## HISTORIC AND DESIGN REVIEW COMMISSION

December 20, 2023

**HDRC CASE NO:** 2023-243  
**ADDRESS:** 411 E EVERGREEN  
**LEGAL DESCRIPTION:** NCB 396 BLK 29 LOT 9 & W 14 FT OF 10  
**ZONING:** R-6, H  
**CITY COUNCIL DIST.:** 1  
**DISTRICT:** Tobin Hill Historic District  
**APPLICANT:** GLADYS AYARZAGOITIA/GMAM  
**OWNER:** GLADYS AYARZAGOITIA/GMAM  
**TYPE OF WORK:** Fenestration modifications, porch decking replacement, balcony railing installation  
**APPLICATION RECEIVED:** November 30, 2023  
**60-DAY REVIEW:** January 29, 2023  
**CASE MANAGER:** Claudia Espinosa

WINDOW SCHEDULE - MAIN FLOOR

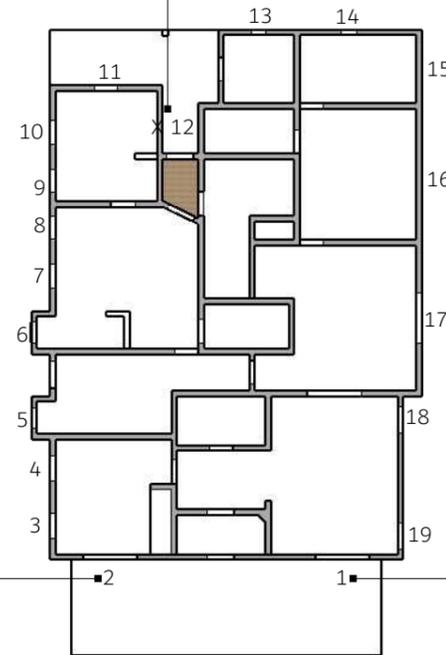
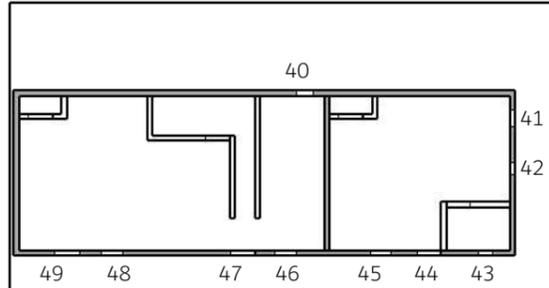
- c. WINDOW INSTALLATION (FRONT FACADE) – The applicant is requesting to install two fixed aluminum windows on the front façade, in window openings 1 and 2, measuring approximately 7.4 ft x 4.4 ft. Guideline 6.A.i. for Exterior Maintenance and Alterations recommends that historic window openings be preserved. New windows should match the historic or existing windows in terms of size, type, configuration, material, form, appearance, and detail when original windows are deteriorated beyond repair. Fully wood windows would be most appropriate. The windows should feature an inset of two (2) inches within facades and should feature profiles that are found historically within the immediate vicinity. Meeting rails must be no taller than 1.25” and stiles no wider than 2.25”. White manufacturer's color is not allowed, and color selection must be presented to staff. There should be a minimum of two inches in depth between the front face of the window trim and the front face of the top window sash. This must be accomplished by recessing the window sufficiently within the opening or with the installation of additional window trim to add thickness. Window trim must feature traditional dimensions and architecturally appropriate sill detail. Window track components must be painted to match the window trim or concealed by a wood window screen set within the opening. Staff finds the installation of fixed aluminum windows to be inconsistent with the Guidelines. Staff finds that the applicant should install fully wood windows that do not alter the existing opening and feature traditional operations.

Item 1, staff does not recommend approval of the installation of two fixed aluminum windows on the front façade, in window openings 1 and 2, based on finding c. Staff recommends that fully wood one-over-one windows are installed that do not modify the existing opening and feature traditional operations. New windows must meet the following stipulation:

Existing (Window#12) will be taken out, It will be divided and we are one on window#1 and the second piece on window #2 (Window #1 & #2)

Existing (Window #12) will be placed on (Window #2)

Existing (Window #12) will be placed in (Window#1)

- i. That the applicant installs a fully wood window that meet staff's standard window stipulations and submits updated specifications to staff for review and approval. The windows should feature an inset of two (2) inches within facades and should feature profiles that are found historically within the immediate vicinity. Meeting rails must be no taller than 1.25" and stiles no wider than 2.25". White manufacturer's color is not allowed, and color selection must be presented to staff. There should be a minimum of two inches in depth between the front face of the window trim and the front face of the top window sash. This must be accomplished by recessing the window sufficiently within the opening or with the installation of additional window trim to add thickness. Window trim must feature traditional dimensions and architecturally appropriate sill detail. Window track components must be painted to match the window trim or concealed by a wood window screen set within the opening.

WINDOW SCHEDULE - SECOND FLOOR

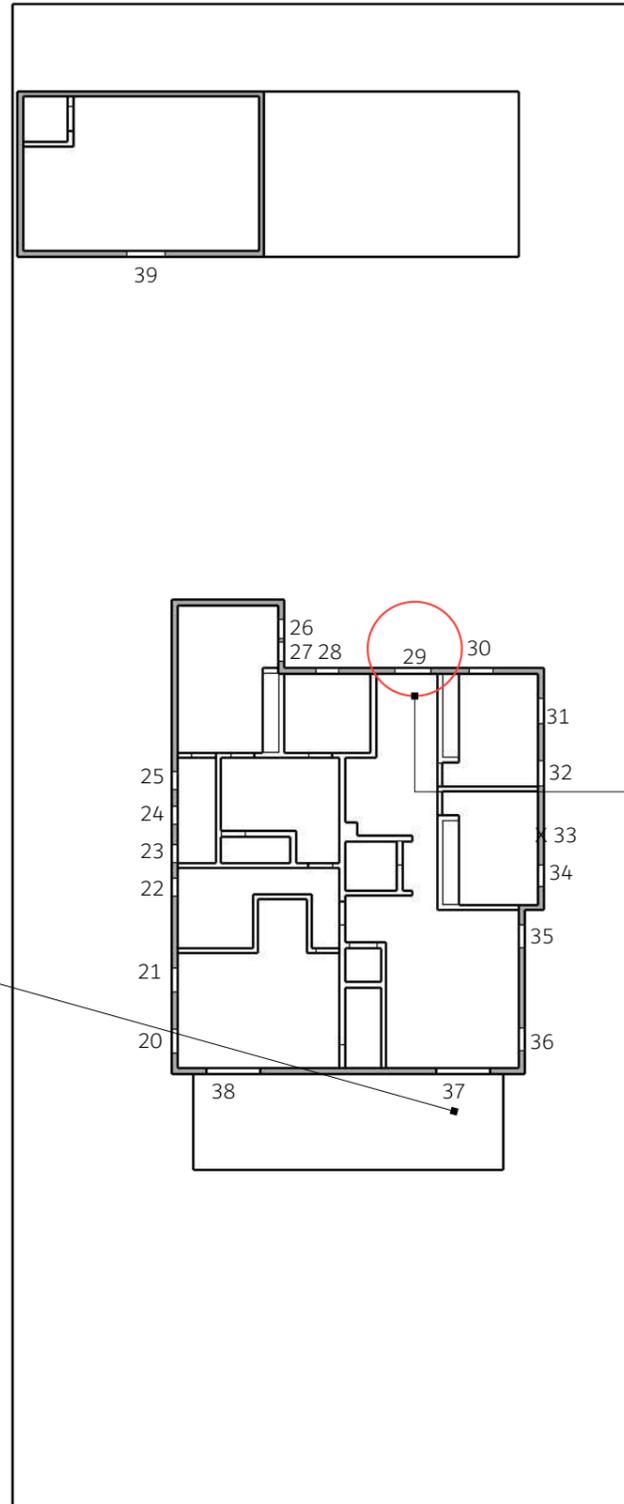
- d. FENESTRATION (SIDELITES, TRANSOMS, AND DOORS) - The applicant is requesting to install two fixed aluminum sidelites and a fixed transom on the second-floor of the front façade, on openings 37 and 38, and salvaged wood doors. The Guidelines for Exterior Maintenance and Alterations 6.A.i recommend that historic window openings be preserved and that New windows should match the historic or existing windows in terms of size, type, configuration, material, form, appearance, and detail when original windows are deteriorated beyond repair. Staff finds that the applicant should install fully wood windows that do not alter the existing openings and feature traditional trim detailing.

Item 2, staff recommends approval of the installation of new windows and salvaged doors within the existing openings based on finding d with the following stipulation:

There is currently no window or door on #37 and #38, but the preparation for it is there, the proposal is to place an existing door with sidelites and transoms on each side (See picture attached).

- i. That the applicant installs a fully wood windows that meet staff's standard window stipulations and submits updated specifications to staff for review and approval. The windows should feature an inset of two (2) inches within facades and should feature profiles that are found historically within the immediate vicinity. White manufacturer's color is not allowed, and color selection must be presented to staff. There should be a minimum of two inches in depth between the front face of the window trim and the front face of the top window sash. This must be accomplished by recessing the window sufficiently within the opening or with the installation of additional window trim to add thickness. Window trim must feature traditional dimensions and architecturally appropriate sill detail. Window track components must be painted to match the window trim or concealed by a wood window screen set within the opening.
